Subject: H13-D021 (Starbucks and Burger King)

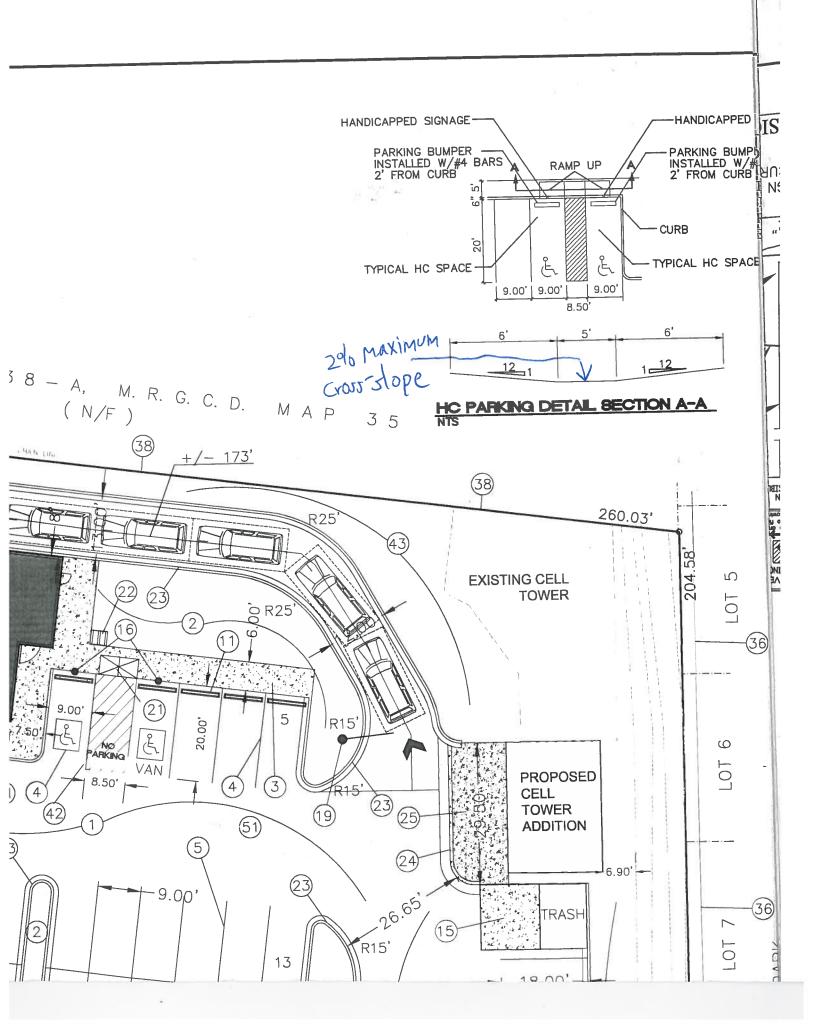
Shawn, as discussed earlier, go ahead and revise the TCL to add a ramp on each end of the pedestrian way from the handicapped spot in the middle of the parking lot (as shown per first attachment).

As per the second attachment, make sure that the curb ramp shows a maximum 2% cross-slope on the ramp.
